AHTD-BRIDGE DIVISION
GUIDELINES FOR FOUNDING FOOTINGS IN ROCK

6/14/94
 PER DFL, LET'S BEGIN
 ADDING THE NOTE
 REGARDING ELIMINATING
 FIELD SPLICES ON
 CONTINUOUS STEEL
 BEAM/GIRDER SPANS.
 CIRCULATE-OUR TEAM

CAL BEAM ELEVATION
 No Scale

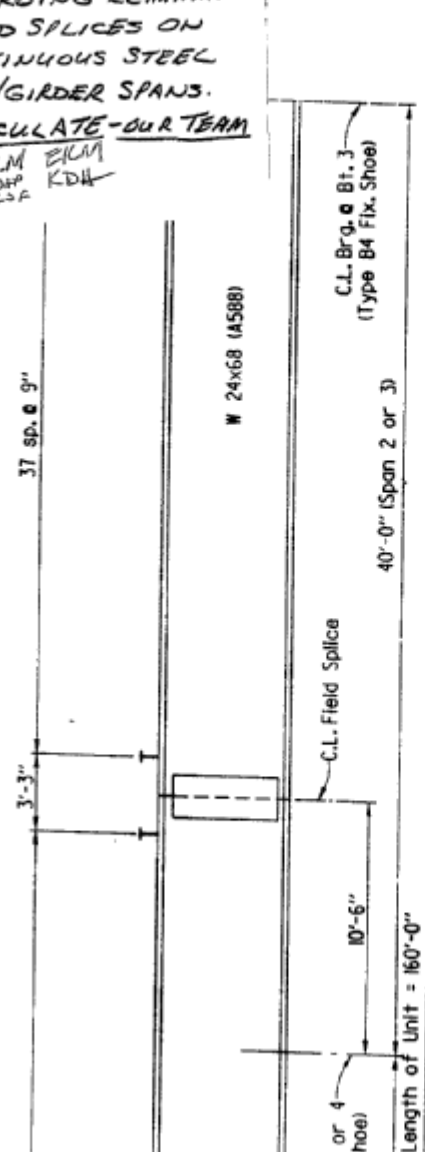
Note: Bolted Field Splices shown may be eliminated or shop welded splices
 may be substituted with approval of the Bridge Engineer. Payment will be
 made on the basis of the ~~bolted-splice shown~~
PLAN QUANTITIES.
